ADDENDUM NO. 3

November 5, 2021

CROWN POINT HIGH SCHOOL ADDITIONS AND RENOVATIONS
Crown Point, IN 46307

This Addendum consists of Pages ADD 3-1 through ADD 3-2 and attached Addendum No. 3 from Gibraltar Design dated November 4, 2021 and consisting of 19 pages, Specification Section 08 34 73 - Sound Control Door Assemblies, Specification Section 11 66 43 - Scoreboards, and 107 drawings.

1 A-101 UNIT "A" FIRST FLOOR PLAN
SCALE: 1/8" = 1'-0"

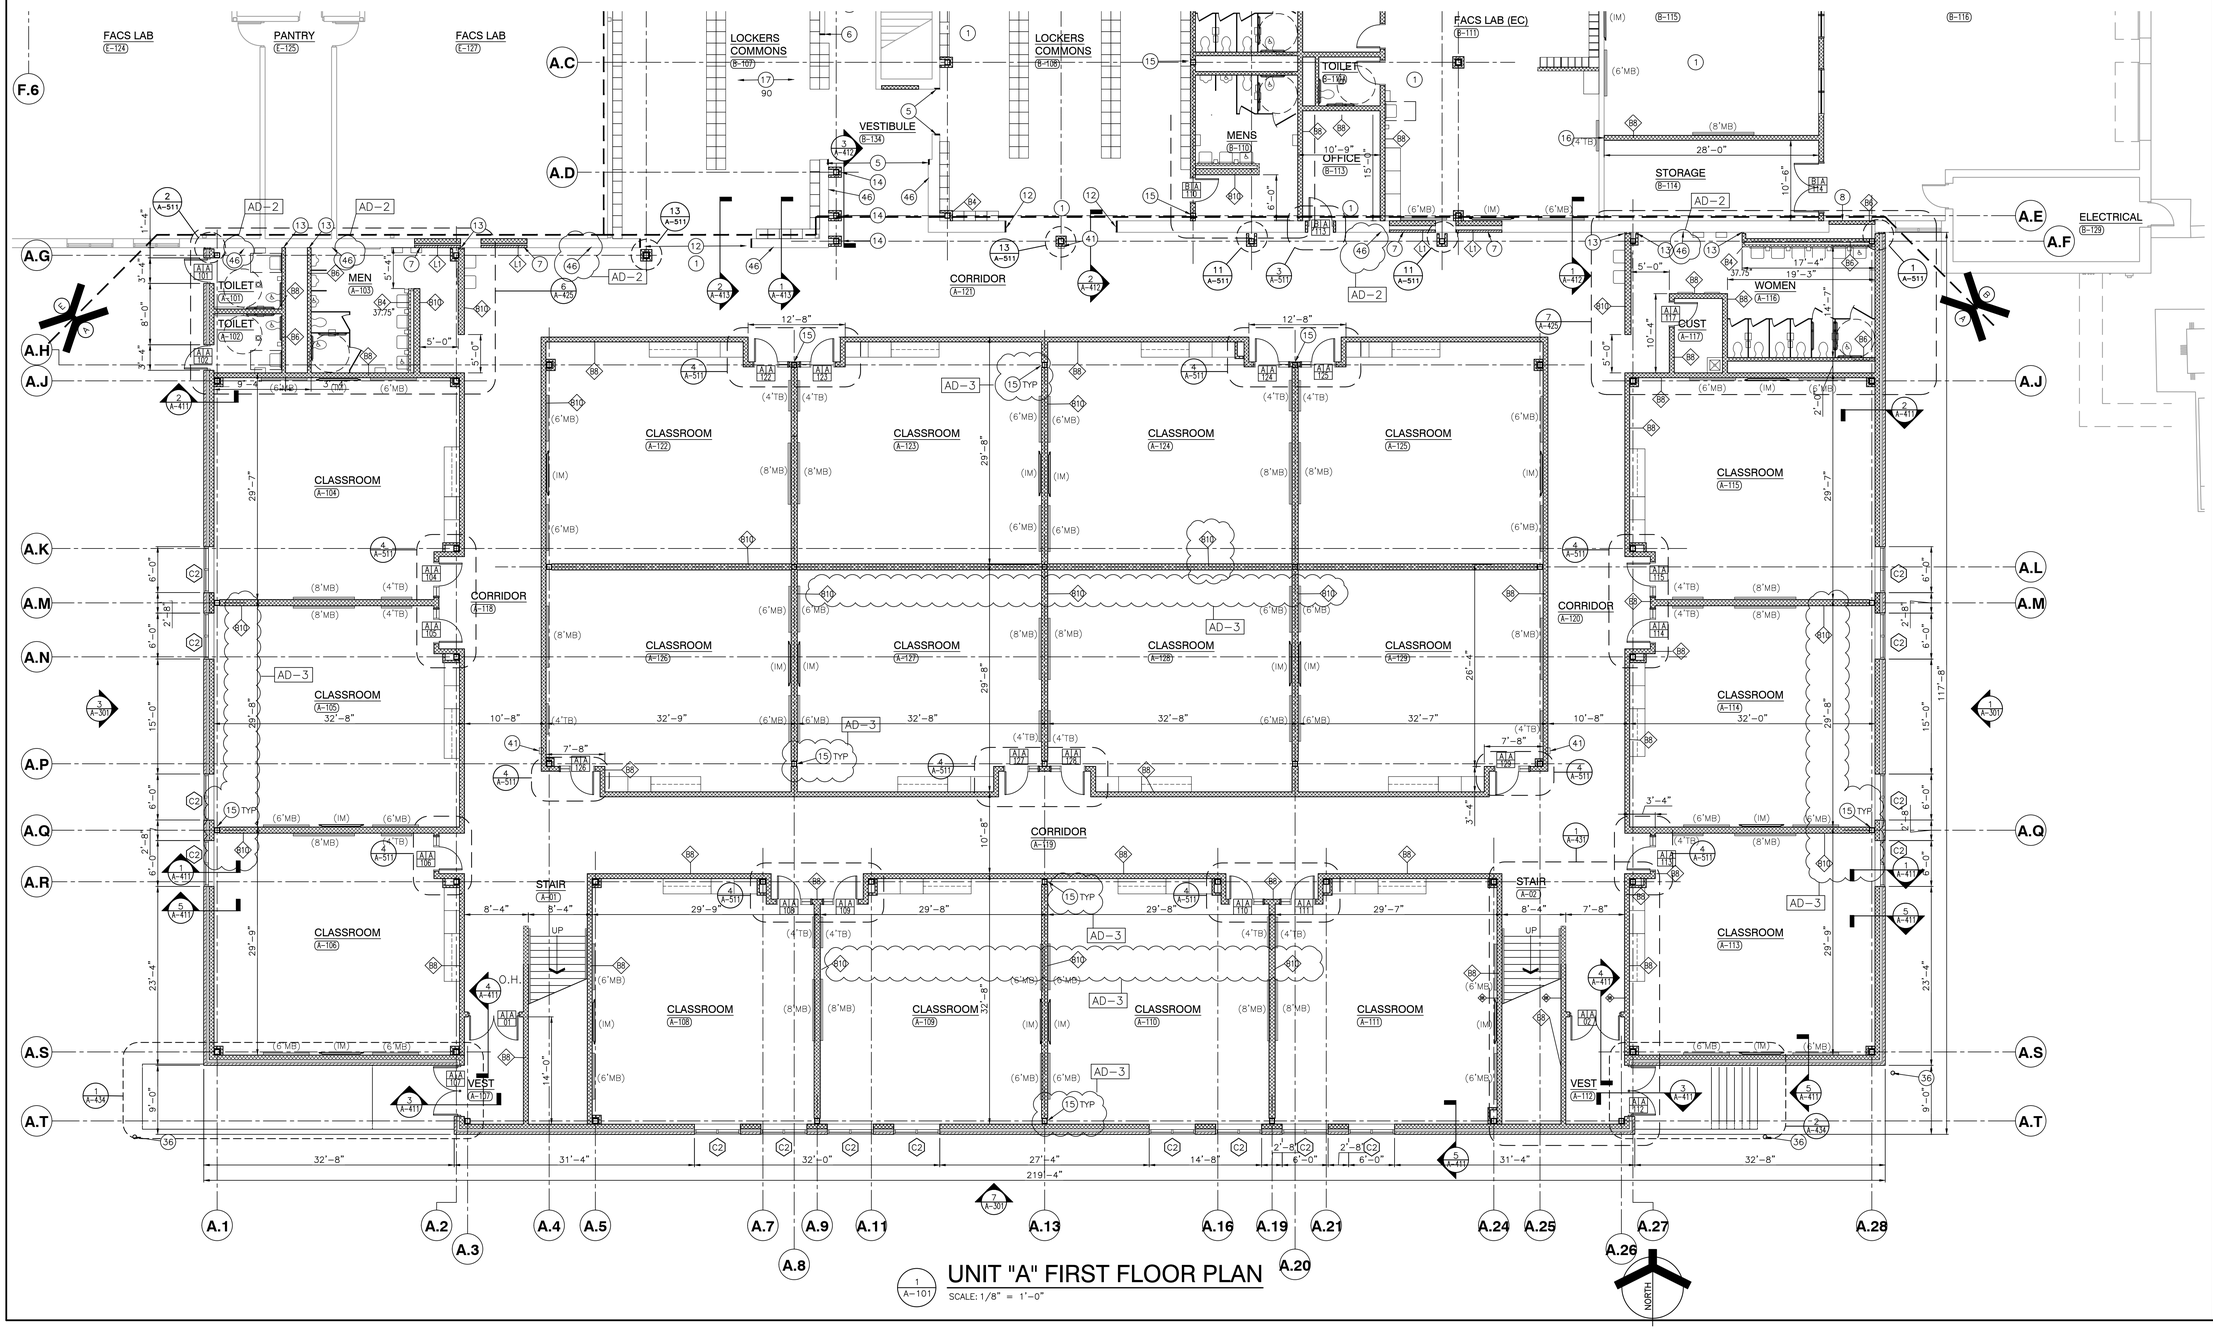
12. Sheet A-101

1 A-110

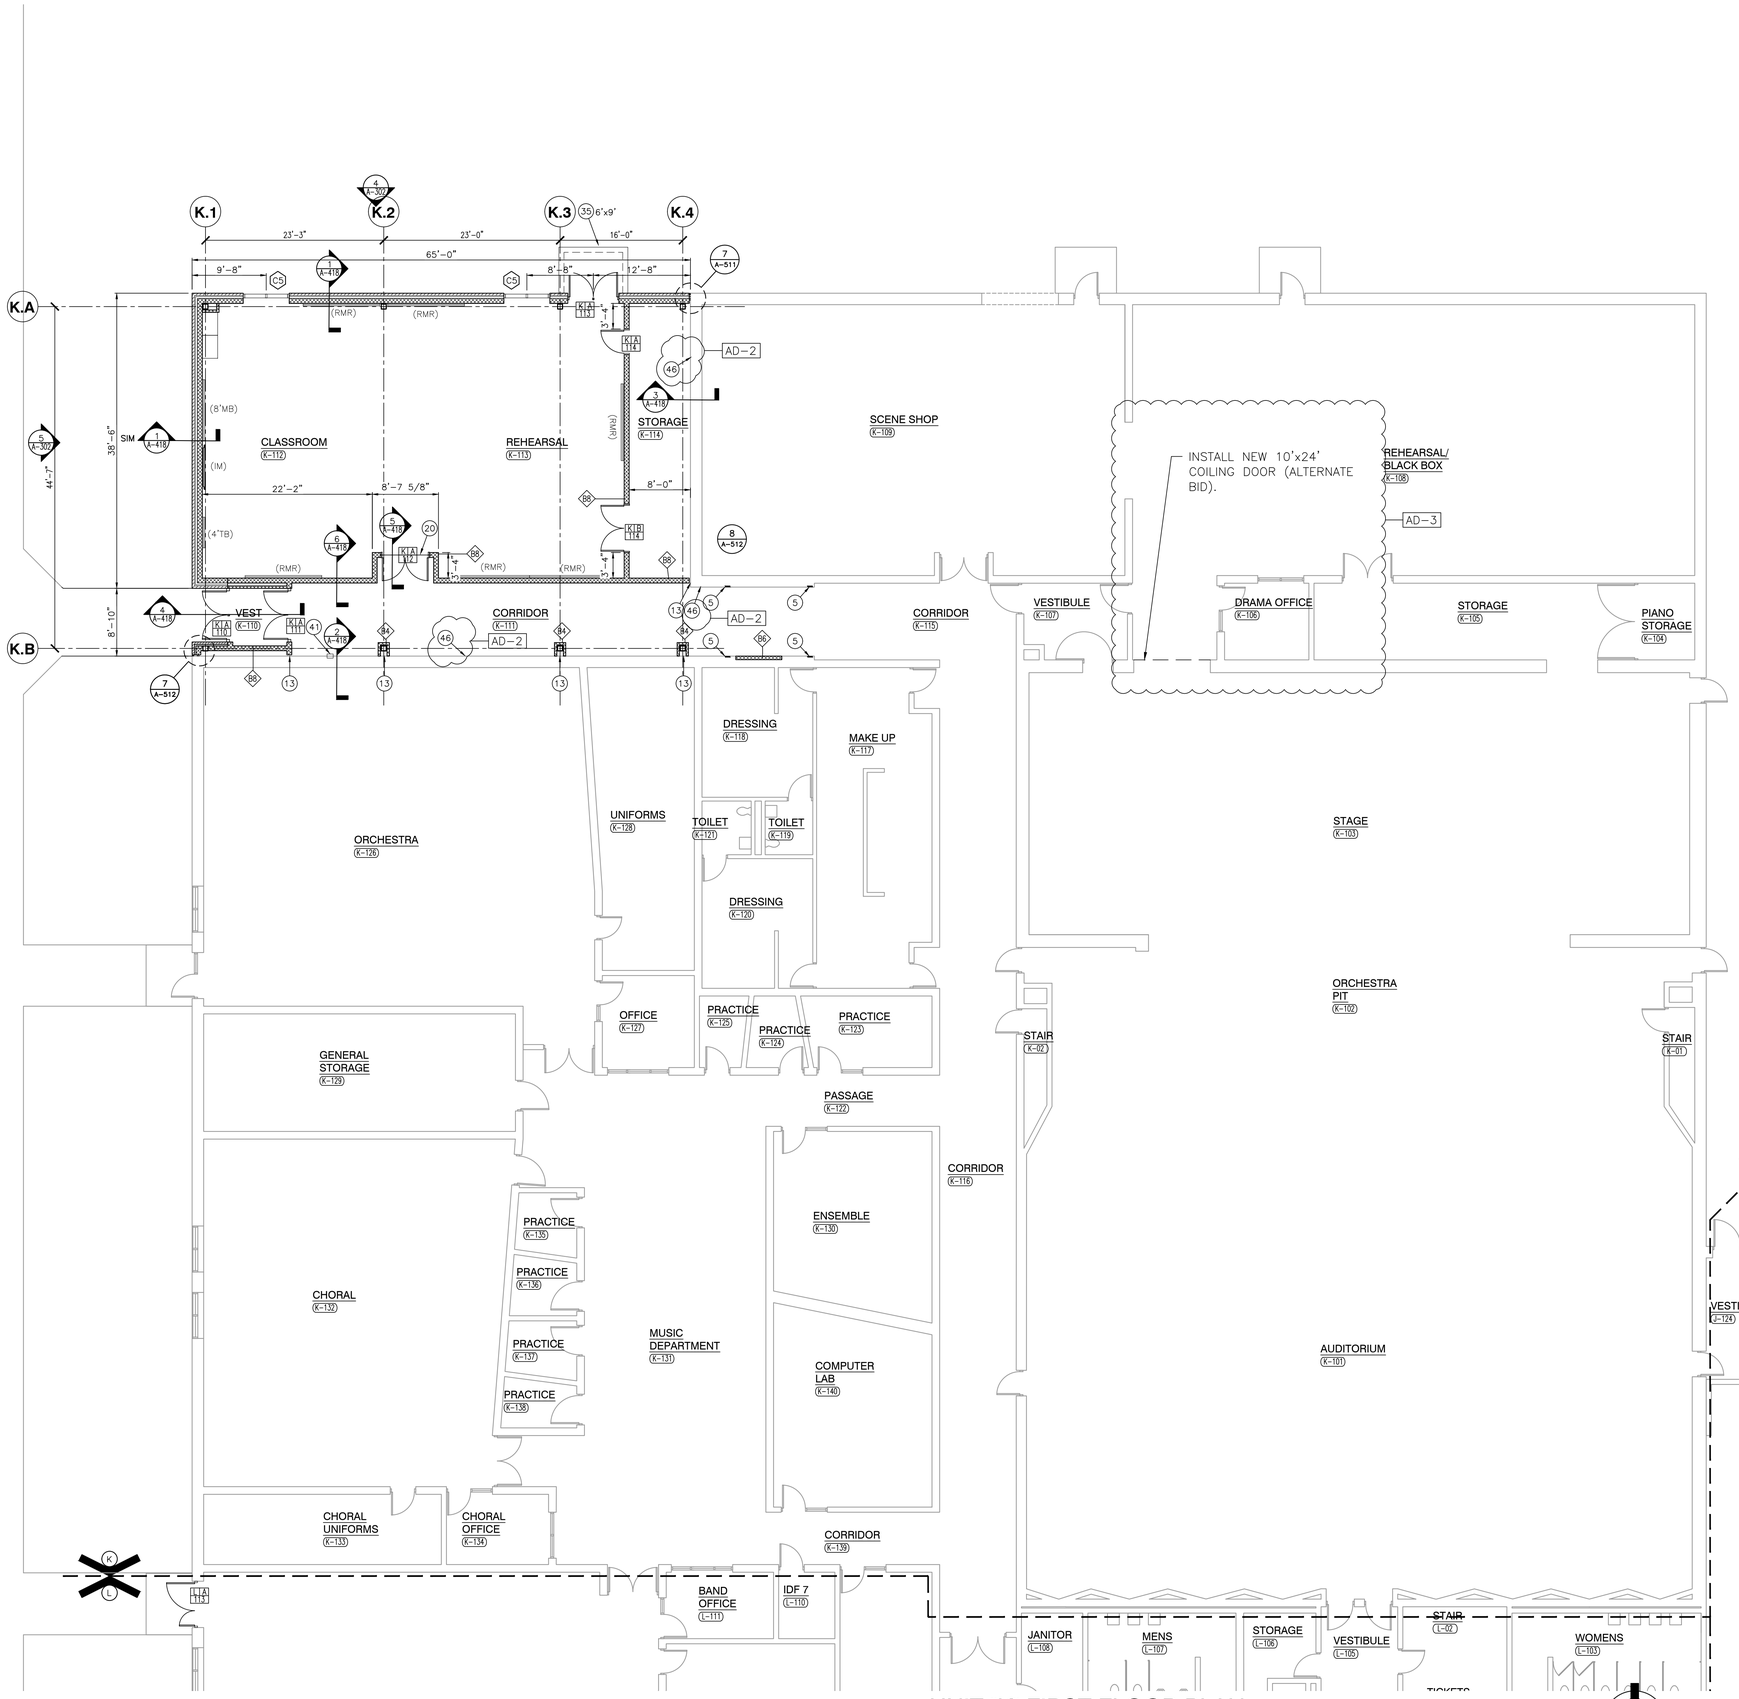
15. Sheet A-110

1 A-115 UNIT "P"/ "R" FIRST FLOOR PLAN

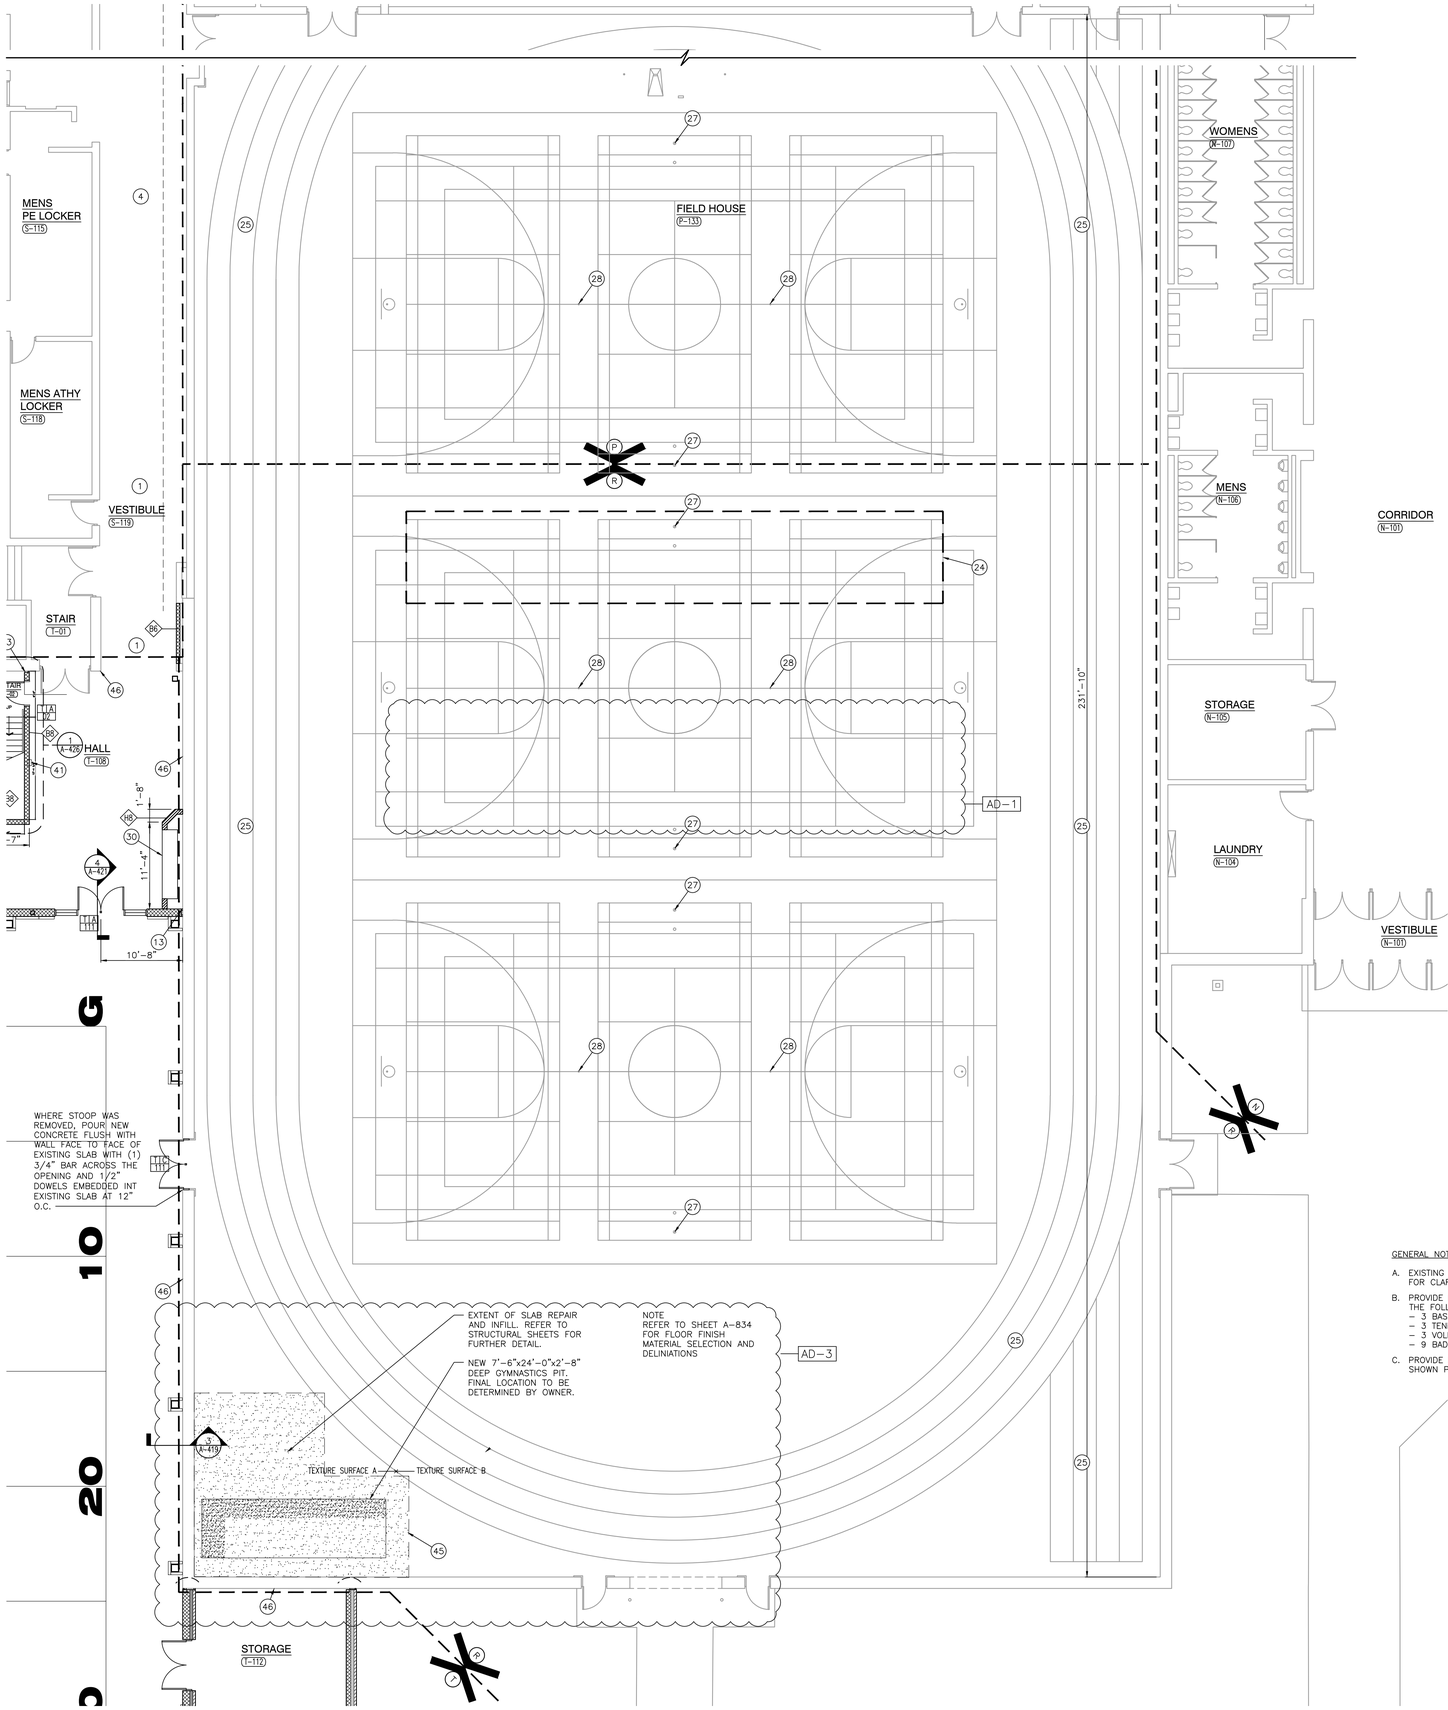
16. Sheet A-115

A. Refer to revised, full -size drawing, included in this Addendum for the addition of a gymnastics pit in the southwest corner of the fieldhouse, and removal of flooring delineation (refer to sheet A-834).

1 A-118 UNIT "A" SECOND FLOOR PLAN

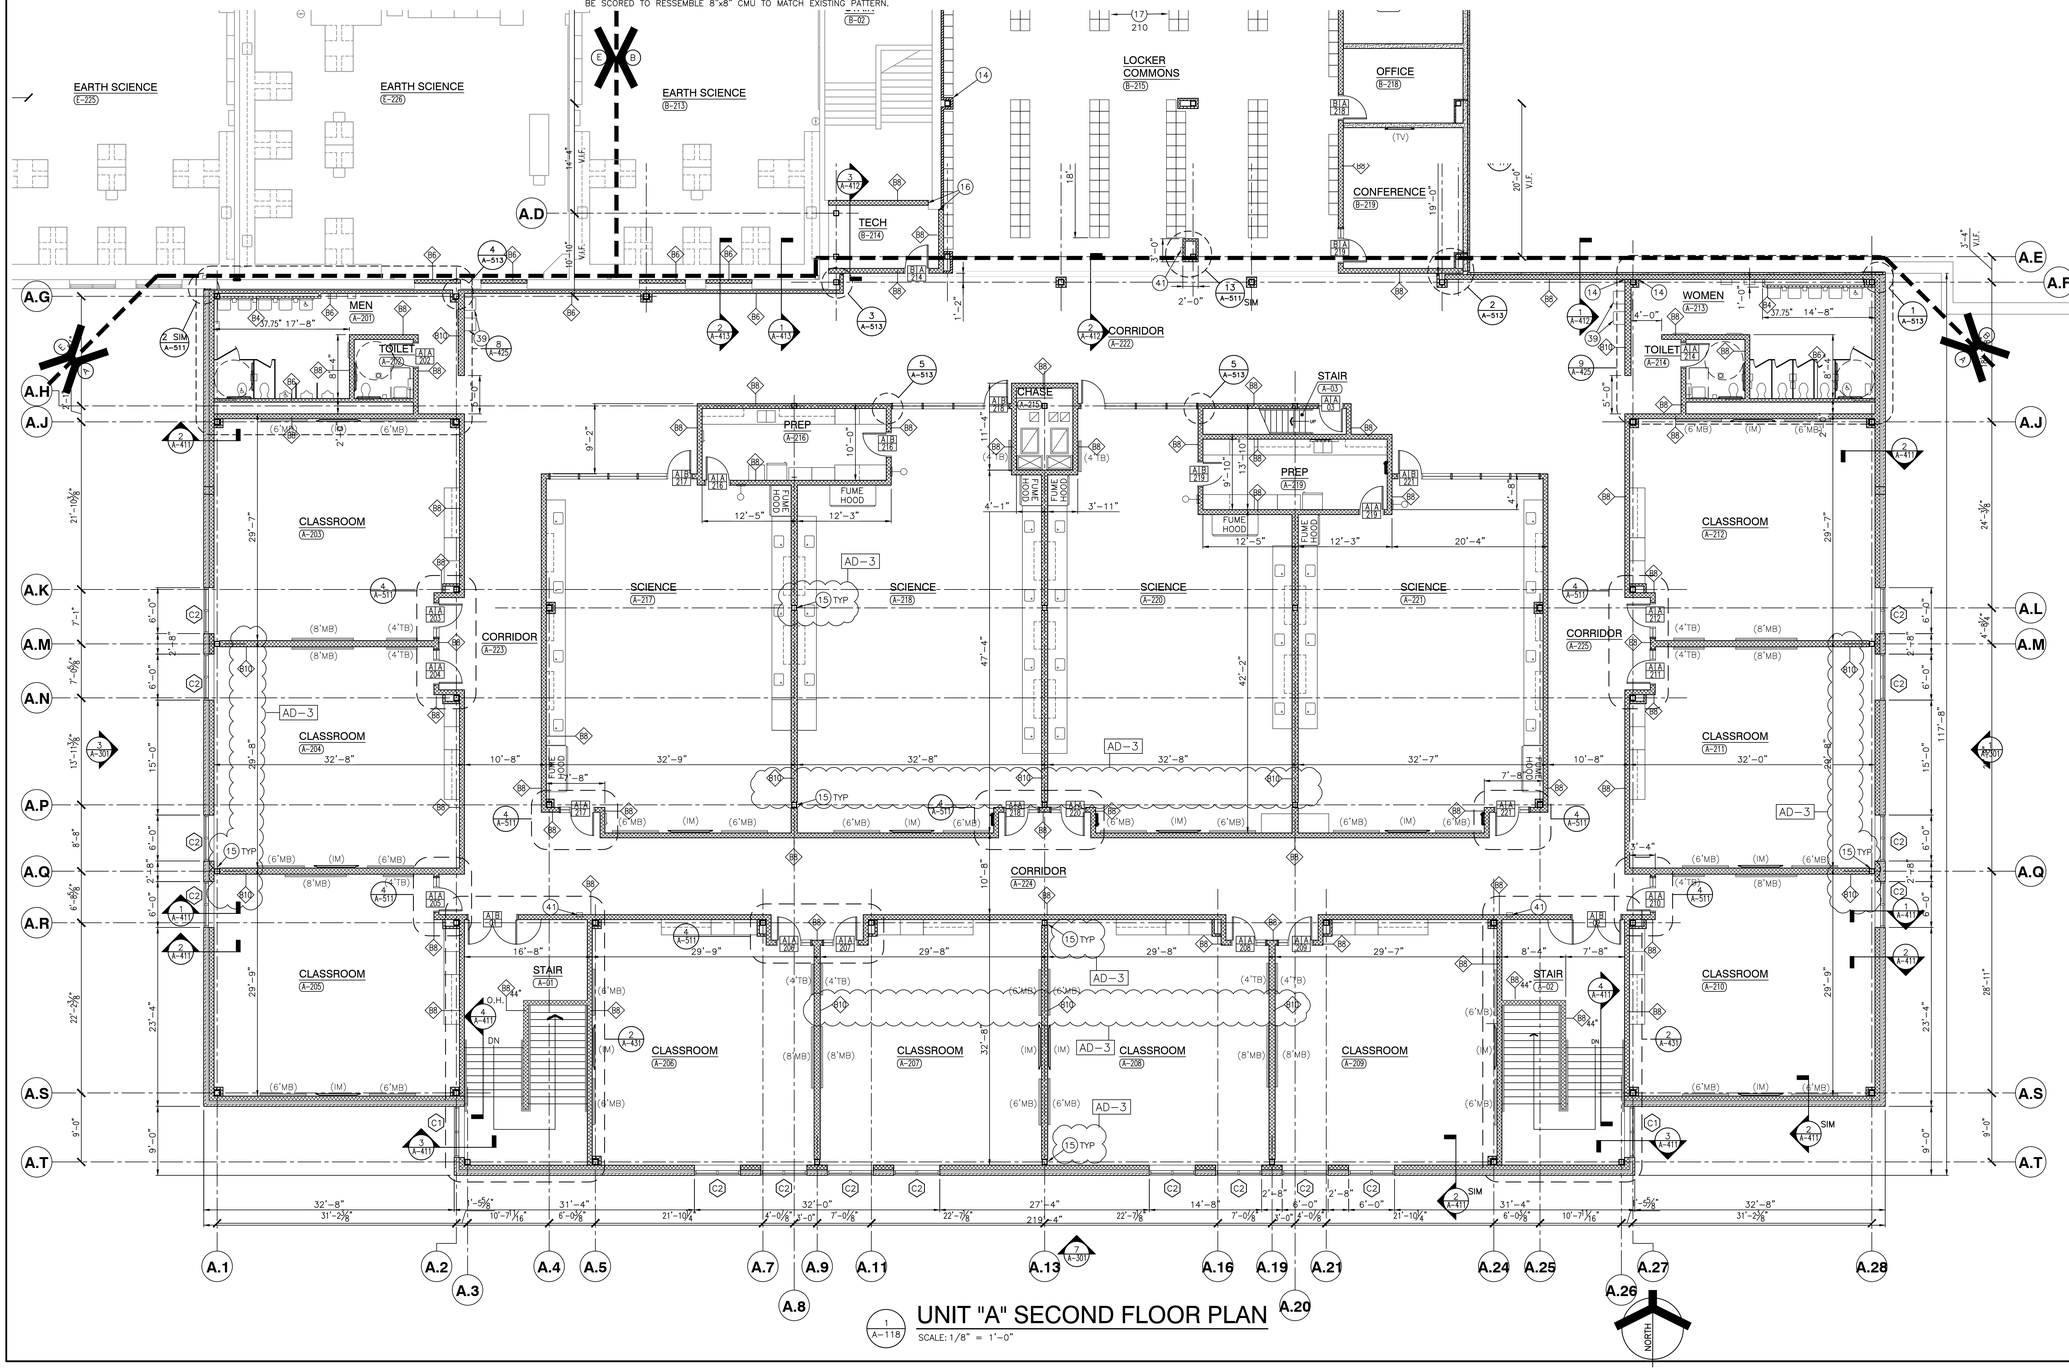
18. Sheet A-118
